LEGAL DESCRIPTION:

CHURCH AT BENT GRASS MEADOWS
GRADING & EROSION CONTROL PLANS

PCD FILE NO.: SF268

GRADING & EROSION CONTROL PLAN
FINAL GEC PLAN

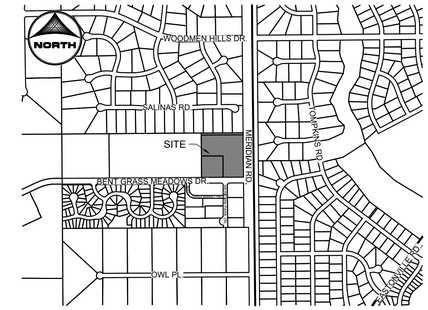
Provide detail and min dimensions for northern swale as well

Will riprap or other dispersion/erosion control measure be needed where this swale ends?

Unresolved - provide swale dimensions/detail. Is the 3.5' the width? The depth? etc? We especially need the min depth required for constructibility

Also callout and provide all min dimensions for the swale that is located on the west side of the proposed earthen berm.

Pond to be in a tract or easement - show in this plan

HRG Response:
"Earthen Berm" removed. North and west swale width, minimum depth, and details added.

HRG Response:
Riprap armoring added to end of north and west swales.

HRG Response:
Drainage easement now shown.
